RIVER VALLEY WAYFINDINGPUBLIC SURVEY RESULTS
2016

Integrated Strategic Development- Citizen Services- City of Edmonton

Introduction – Background and Objectives

Park Identification Sign

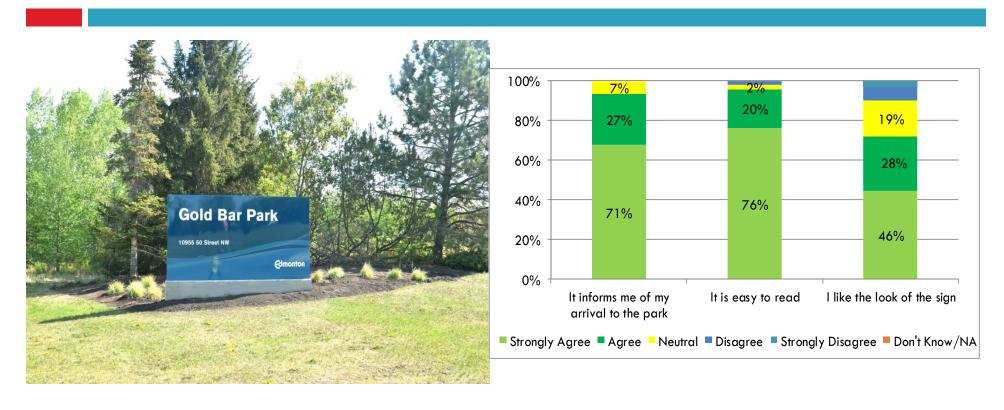
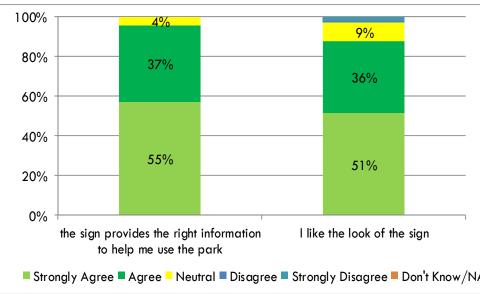
"I would like an arrow pointing to the parking lot as it is far from the sign and you have to drive past the water treatment plant."

"... it would be nice to have information about the activities that happen in the park. For example, Gold bar is a huge x-country skiing park and many people don't know that."

"I feel the sign could have a "greener" look it. It's something I'd expect to see entering a government building, not a nice green park."

"It's alright. I tend to like the look of the current signs with the wood feel. I like that they blend with the outdoor look"

Suggestion regarding the material: reflective, readability in the dark, resistant to graffiti (8)

"... will the sign be easily read in the winter months when the sun goes down early?"

Park Information Sign

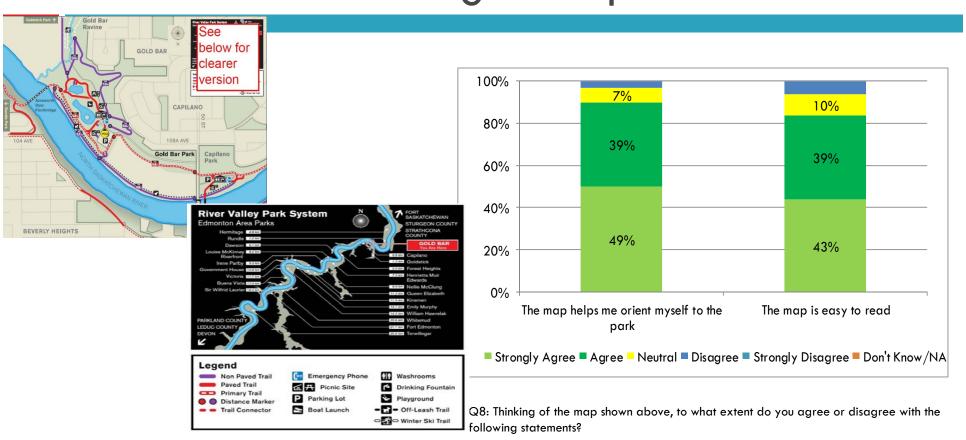
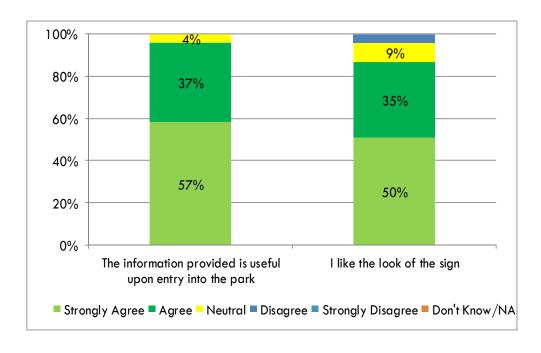
"...to include some way of direction to catch or use public transportation to get to and from the park area from various locations. it is rather large and many people visiting the park may not always have access to a vehicle. Isn't this part of the mayor's wish to make it easier for pedestrains and low-income individuals using park/s areas?"

"...1) Signage needs to be worded more strongly regarding dogs, such as "Dogs on the off-leash trail must be kept under control at all times". (This is an ongoing problem throughout the trail system, so please take this opportunity to do something with this new signage.) 2) Cyclists - Use your bell when approaching other trail users."

"I would love for the map to also indicate how long it would be to get to Rundle Park, GoldstickPark and Downtown Edmonton instead of just pointing in the general direction they are. It would also help if it was clear if I can walk to those points using the trail system or not. It would also be nice to know of any amenities near the park that might meet some needs not met in the park (specifically food and drink services)"

"It is confusing that the first map, North is 'down' and on the second map, North is 'up'. Also, the direction of North is not immediately clear."

"Why is the top map oriented opposite to the correctly oriented second map? Please be consistent with where North is on the maps!"

"North should be at the top. I looked at this and was confused immediately since gold bar is 'below' the river to me...the map should have north at the top, the same as your paper trail maps are (you have 3, east, central & west)..."

"The "Park System" map with distances is far too small and difficult to read...It is key information in a patrons interaction with the trails and should be far more prominent."

"...the small "River Valley Park System Map" is too small to be of real use. The information it contains is excellent and interesting, but IMHO it either needs to be larger or omitted."

Park Entry Sign

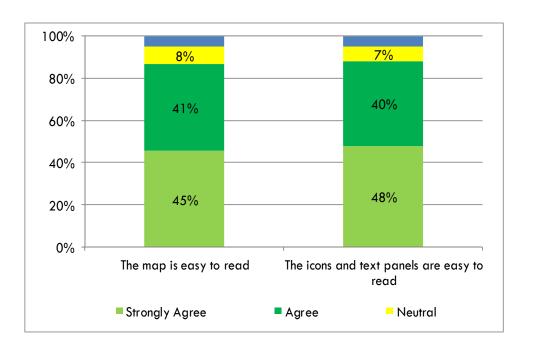
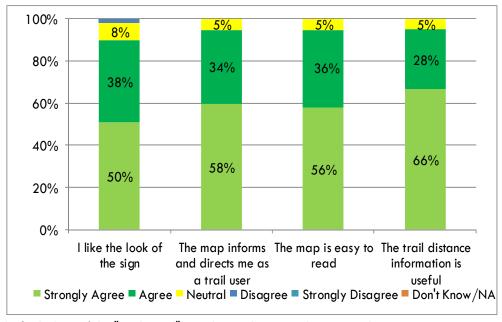
"I think the "you are here" needs to be more obvious. Does this map show all the trails or just the main paved and gravel ones?"

"I'm curious as to the choice of red and purple as trail markers. Was this choice due to increasing readability?"

"Look at marking the 3 different entrance points as entrance #1, #2 and #3 for easy reference to the map locations"

"Was there consideration to show any slope/stair information on the trail maps so mobility reduced and elderly can plan accordingly? I don't think info needs to be super detailed, just an indication that some portions of the trail may be challenging."

"The "SHARE - THE - TRAIL" Logo is jarring and aggressive, and leads to questions with "like who?" and "what is happening on these trails that they need to 'yell' at me about it?"

"Now the map has north at the top which is opposite of the large map - why the switch? All the maps should be like this one, north to the top :) I like the look and the friendly tone"

"As with the previous map sign, I believe the map orientation may be confusing, though the "up is forward" orientation may make sense here. However, I don't think it is reasonable for the main map and the inset park system map to be oriented differently."

"The distance map is far too small. It is key information for trail users and should be larger..."

"The little inset map is almost impossible to read the distances to other parks in the river valley system because the fonts are so small, and the printer resolution isn't that good. The same can be said of the legend, it's hard to read because the text is so small."

Trail Head Sign

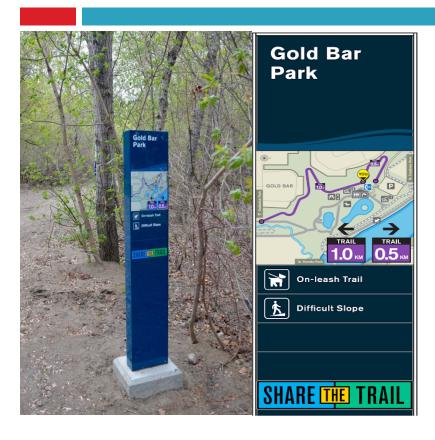
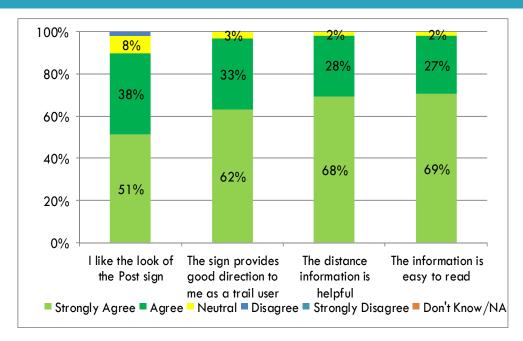
"I really like the trail distance markings. What qualifies as "difficult slope"? I really like that that's included but it's not clear whether the entire trail is difficult or if there is a small portion of the trail that could present some challenges."

"I love how the map shows the distance but I don't know which way the "difficult slope" is. Is it both ways? the shorter way? No clue.... Also, does this portion of the trail have a name?"

"The difficult slope icon - does it apply to both directions? ..."

"The 0.5km Trail distance sign is not clear - does this mean it is 0.5km across the river? Also, where does the 1.0km lead to?"

"...It would be helpful for the map to indicate the location and orientation of the difficult slope, especially as it is not clear whether the slope in question is in the portion of trail to the right or left of the sign."

"Trails should be named or numbered so that you can identify trails easily and communicate what trails you have been on."

- Map orientation confusing, prefers north on top (6)
- "North needs to be pointing up. Rotating it around various directions is confusing."
- □ Very helpful, i.e. trail distance info (17)
- "I like the indication of on/off leash area and the slope level for users."
- "I really appreciate the trail information (distance)."
- "This is a good amount of detail for the size of the map. Simple and easy to read."

Trail Directional Sign-Post

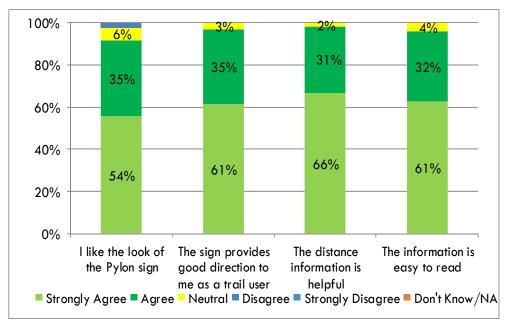
"Nice minimalist design. Perhaps consider adding general compass directions"

"It would be helpful to include a small map on at least one of the panels on these signs."

"It would also help to have amenities like bathrooms, water fountains and shelters listed."

"...Should also provide distances to next washrooms, and to river crossings."

"The font on this sign was too small to read while running or biking. I was annoyed by how difficult the signs were to read as I ran by."

Trail Directional Sign-Pylon

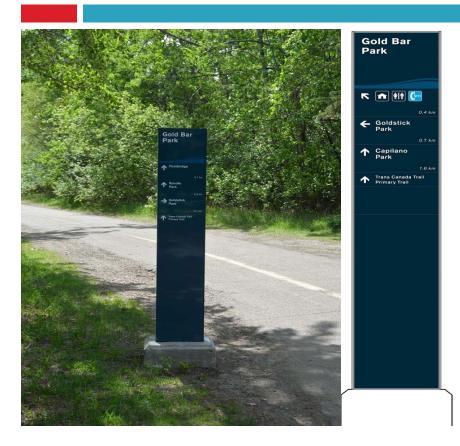
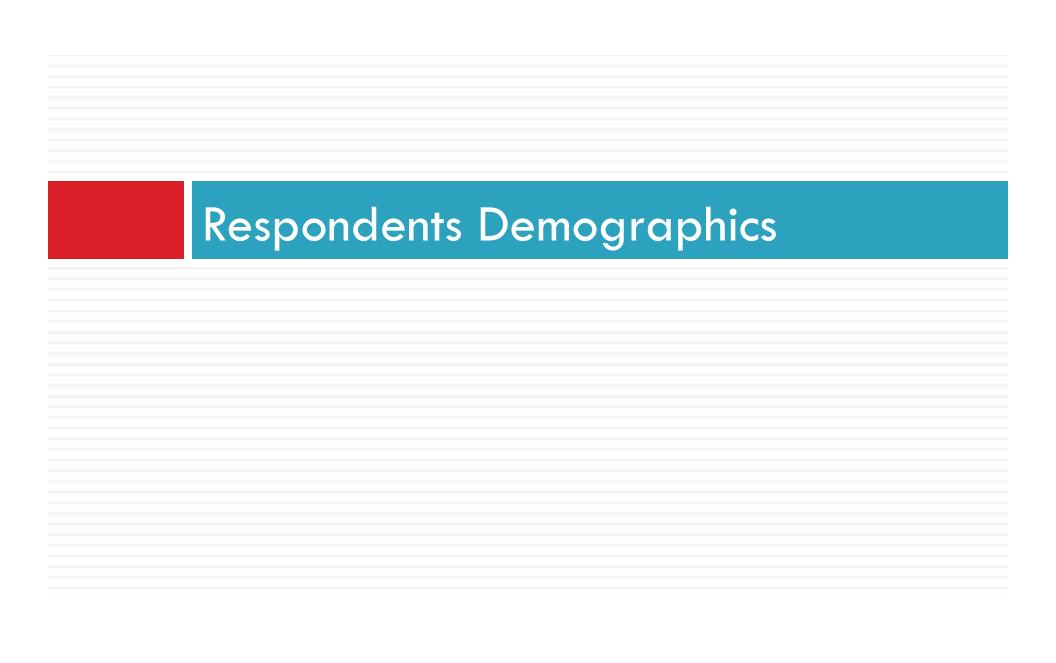
"We are requesting that the TCT logo be incorporated with the words 'Trans Canada Trail' (again - cyclists are not taking the time to read signs, they are looking for quick way finding. direction (ie the logo)..."

"Requires knowledge of where the other parks are relative to where I am. If I want to go downtown I wouldn't know which trail to follow."

"Maps are very useful at important intersections. I believe "Pylon" trail direction sign is large enough accommodate a small map of the immediate area."

"Pylons should be farther off the trail, so they don't interfere with bikers/skiers."
